ORIGINATION FORM

Proposed Revisions to a Standard Plans Index
(Please provide all information — Incomplete forms will be returned)

Index Number: 695-001
Sheet Number (s): 1 through 7
Index Title: Traffic Monitoring Sites

Index Number: 695-001
Sheet Number (s): 6-7
Index Title: Traffic Monitoring Site

CABINET LAYOUT DETAILS (Four Lanes or Less)

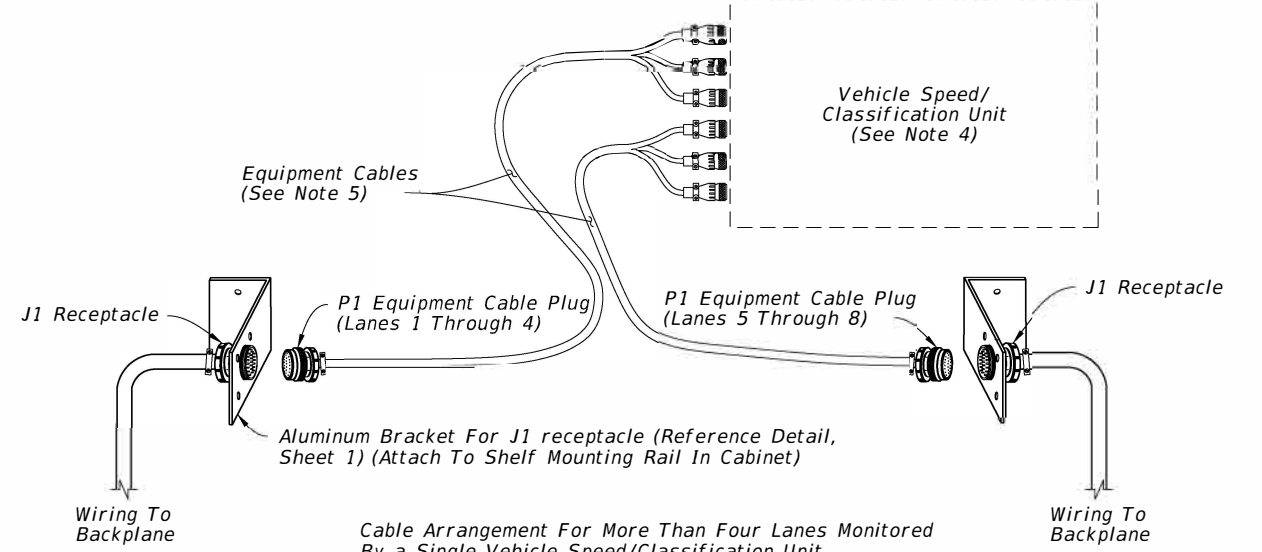
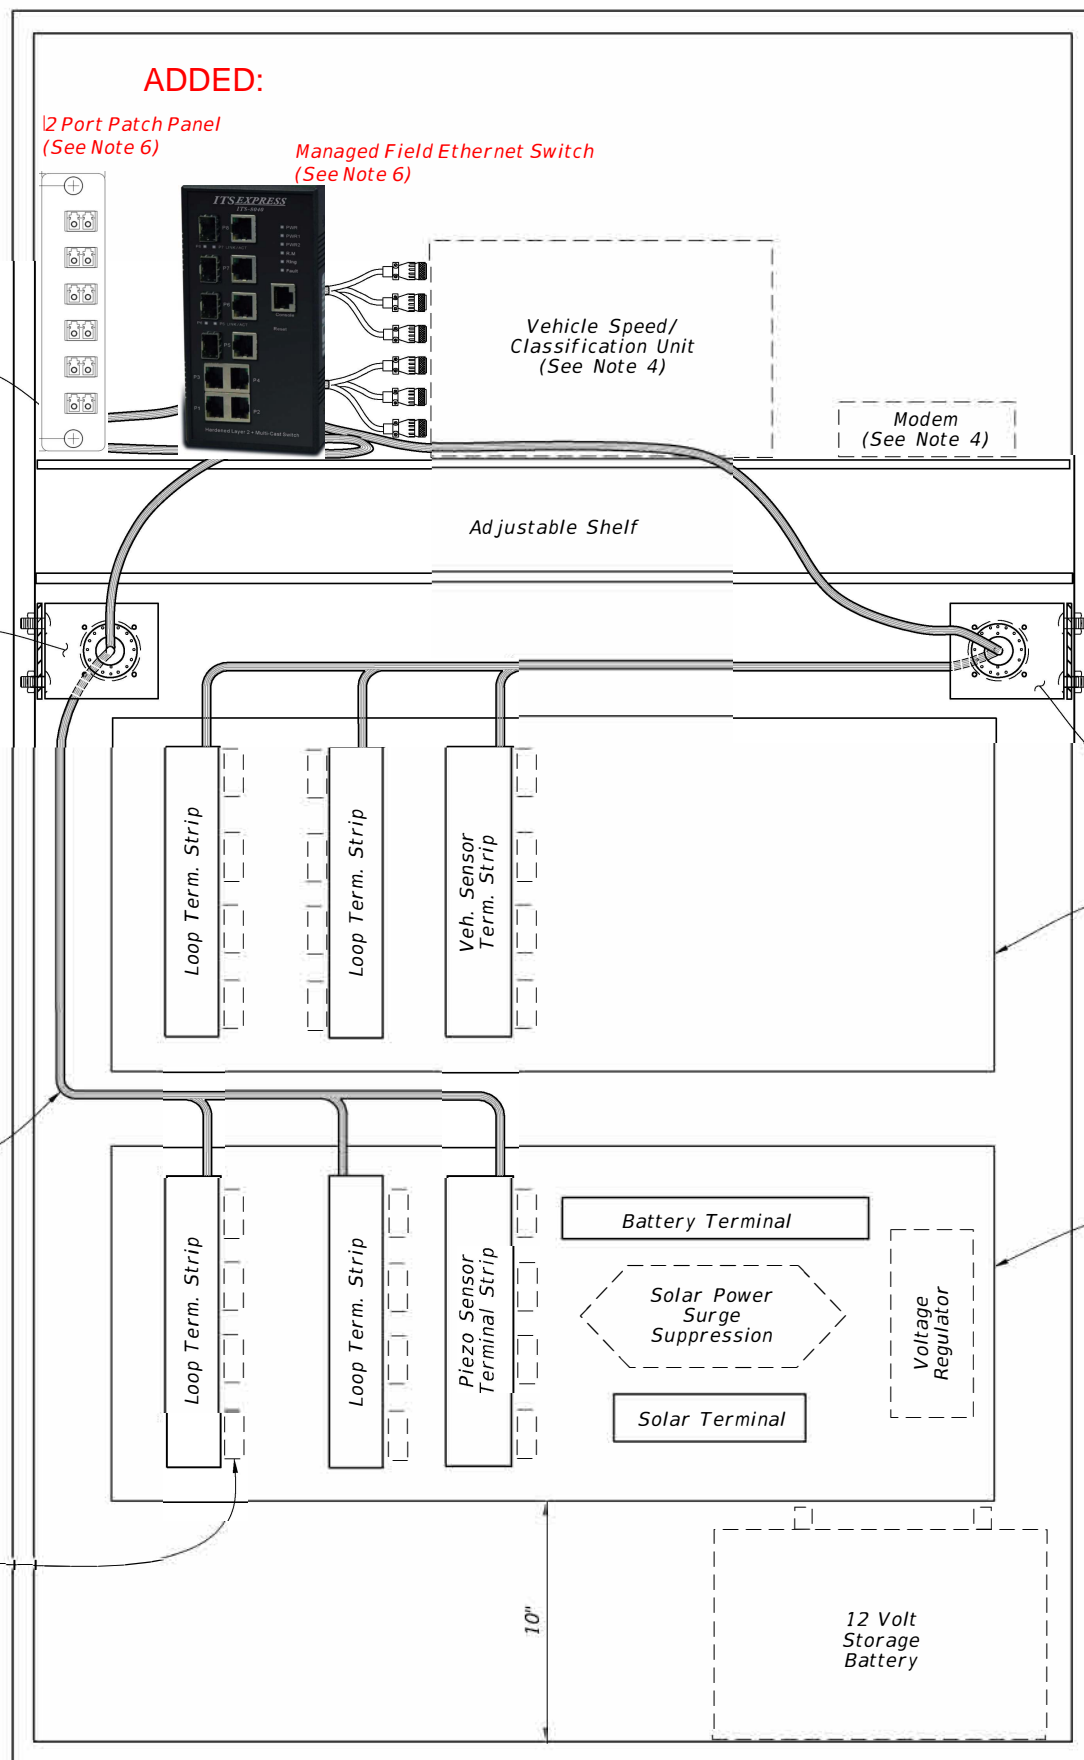
CHANGED TO: Data and Analytics

ADDED: Note 6

ADDED: Note 6 — **CABINET LAYOUT DETAILS (Five to Eight Lanes)**

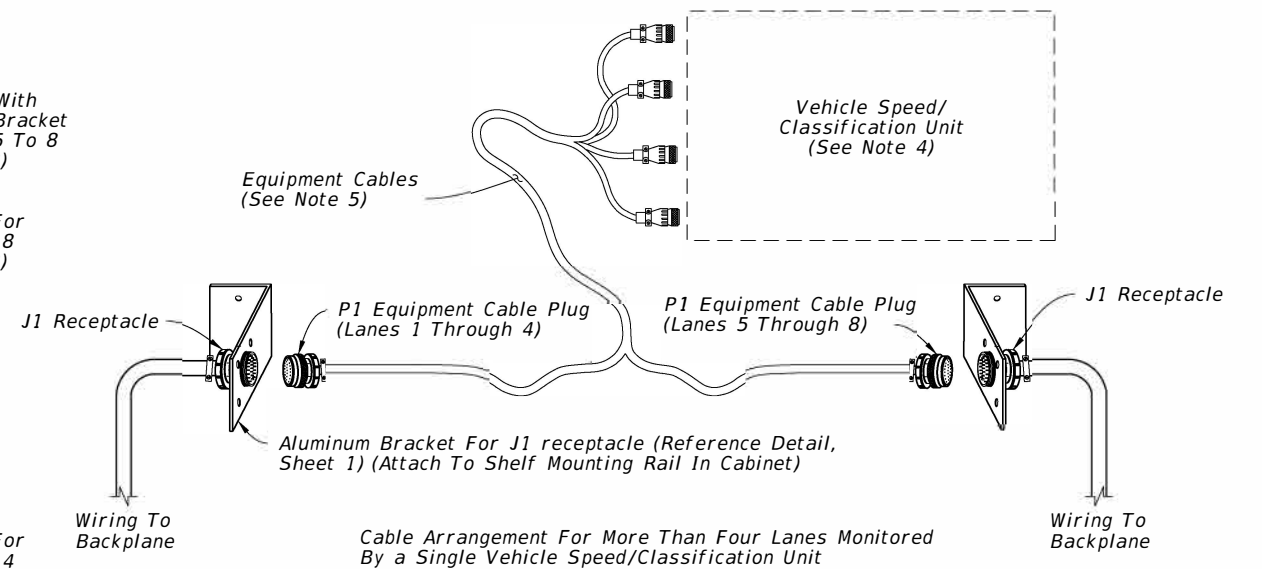
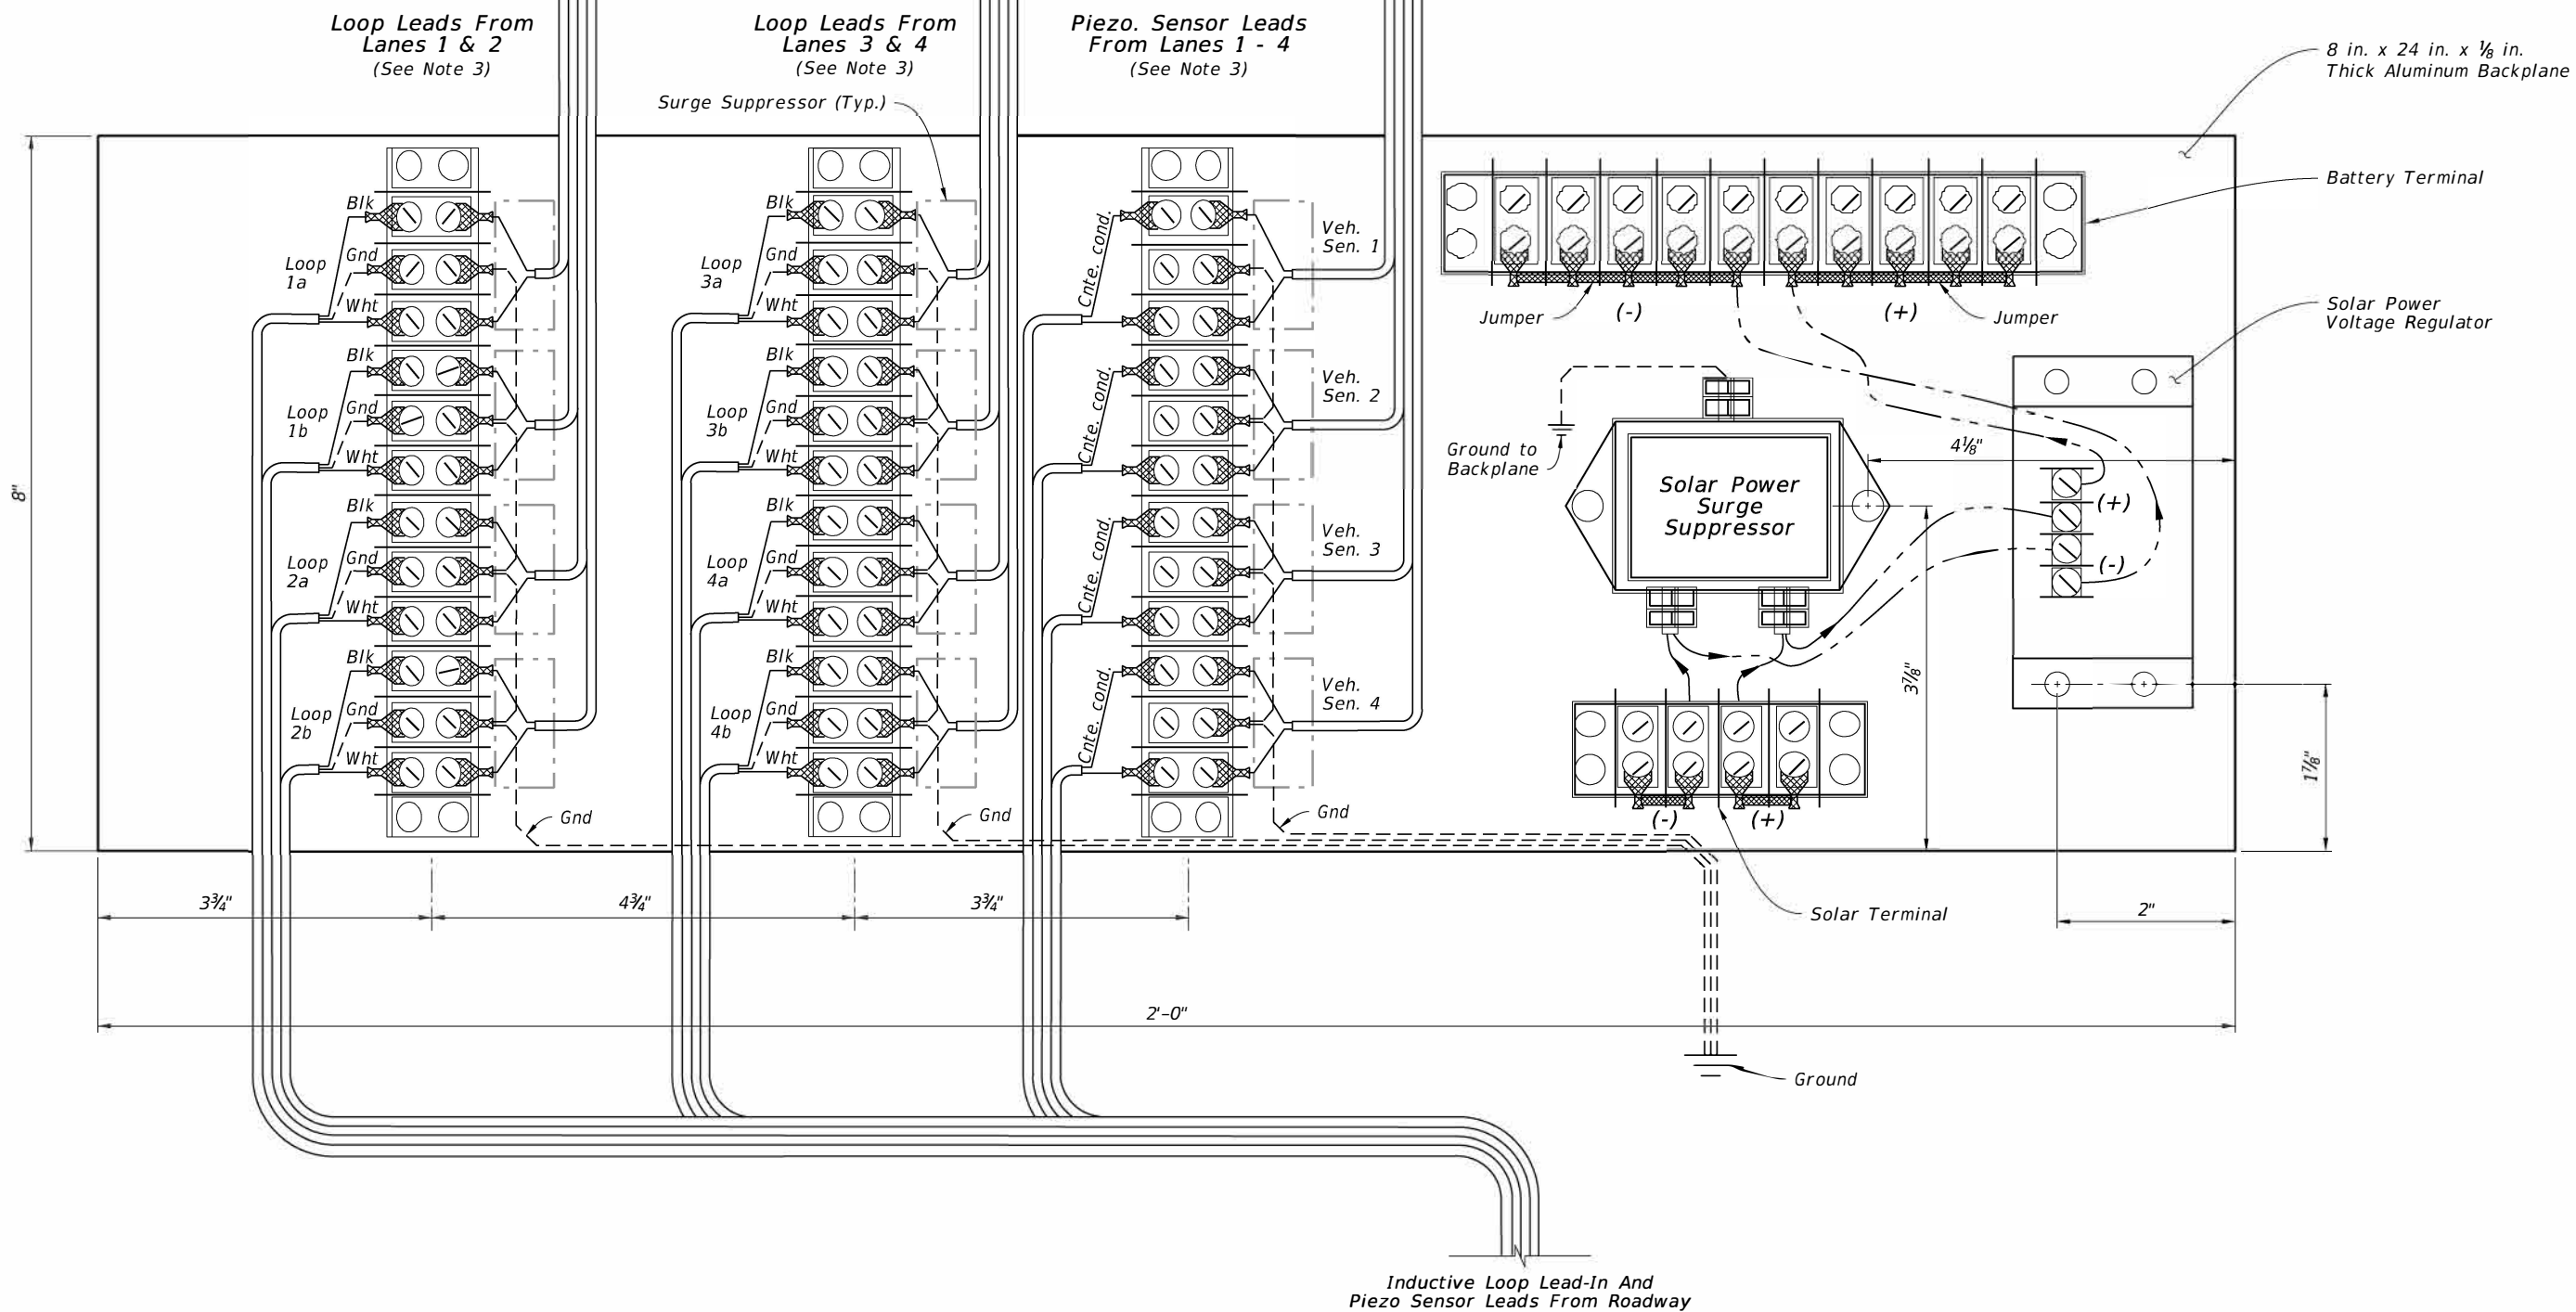
CHANGED TO: Data and Analytics

CABINET BACKPLANE DETAIL

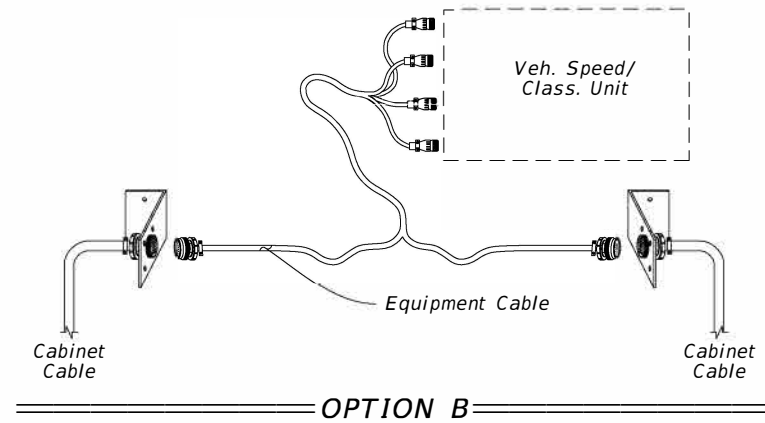
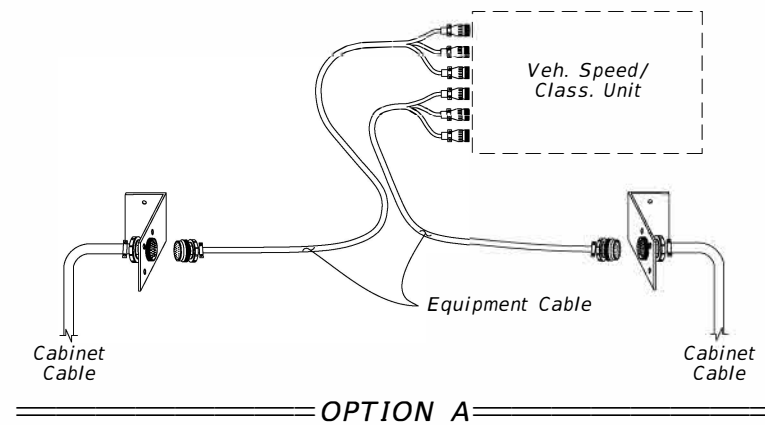
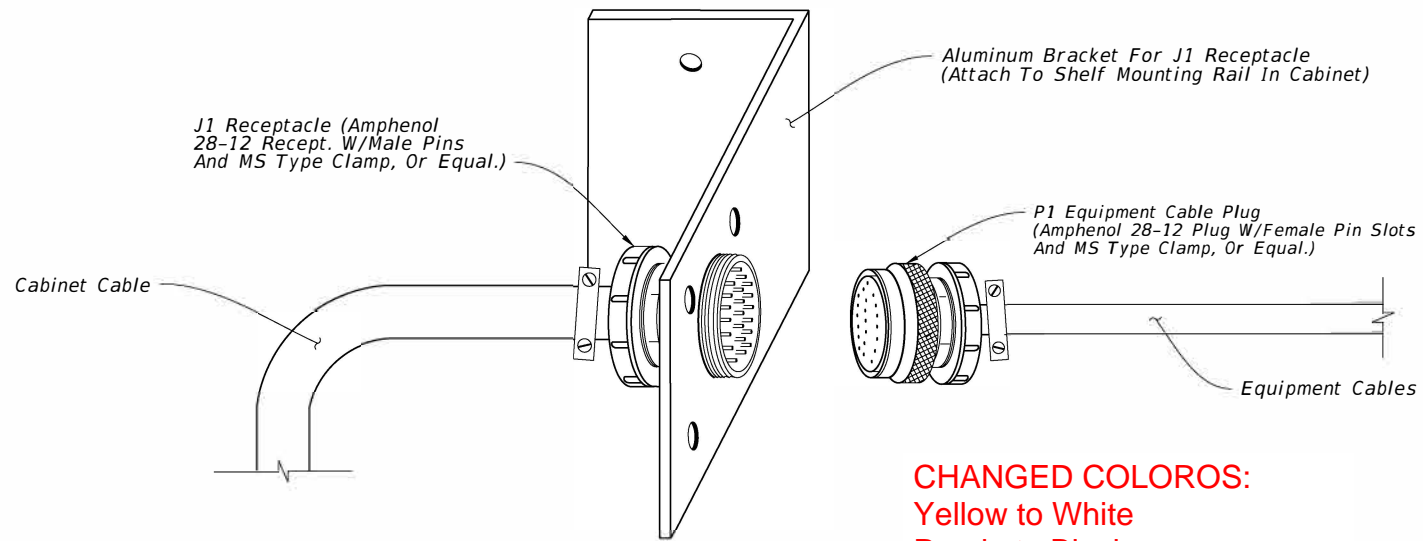
CHANGED TO: Data and Analytics

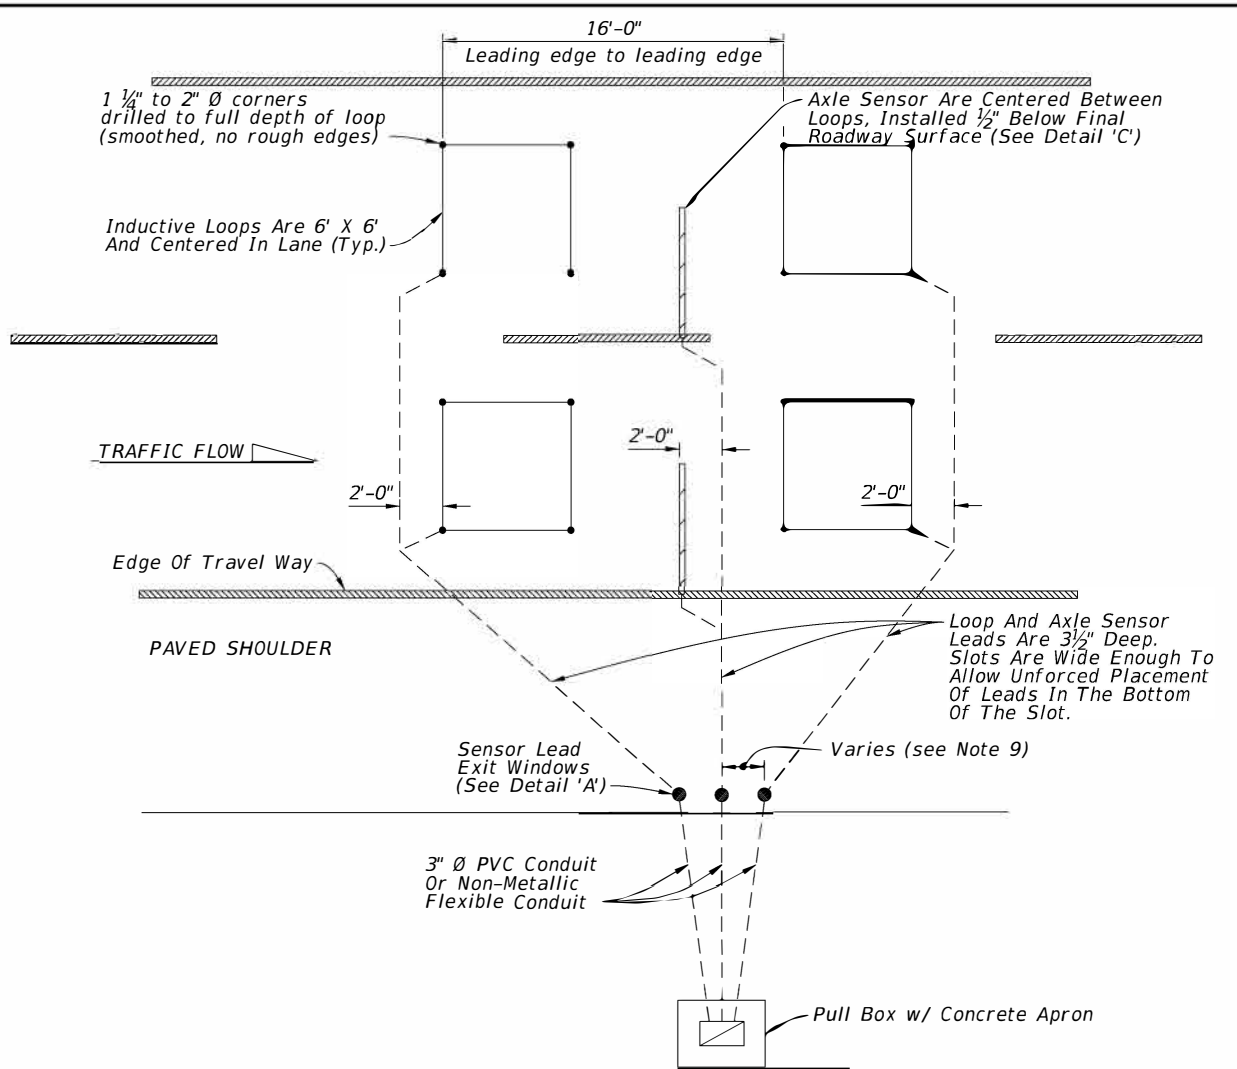
CHANGED COLOROS:
 Yellow to White
 Purple to Black
 Gray to Red
 Pink to Black
 Brown to Green

CHANGED TO: Data and Analytics

CHANGED TO: Green

LANE CONFIGURATION FOR TMS INDUCTIVE LOOP AND QUARTZ PIEZO AXLE SENSOR

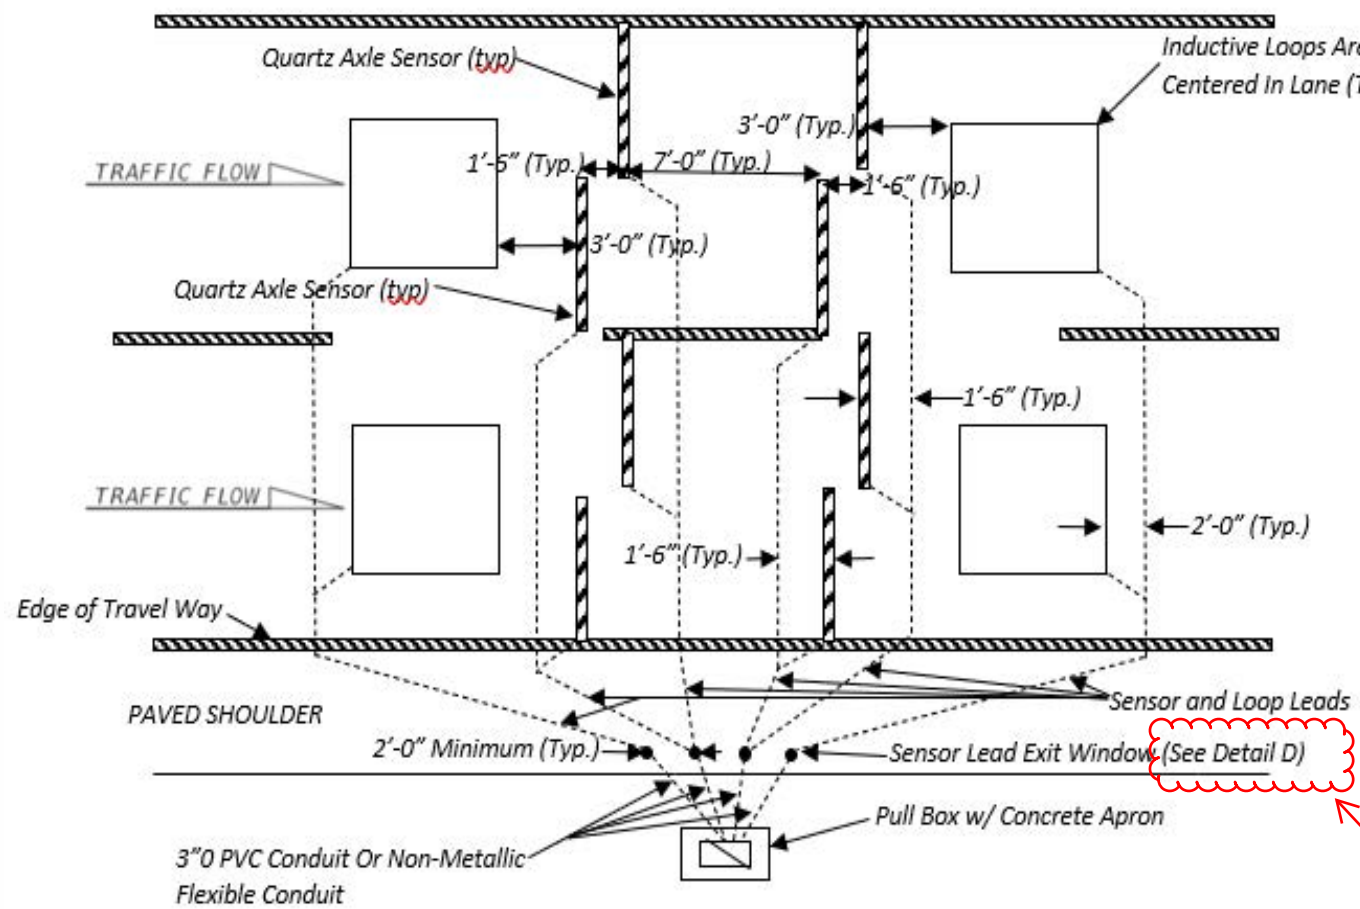
on sheet 5

TYPE I CONFIGURATION

NOTES: Type I configuration used in vehicle classification systems.

NEW SHEET 6
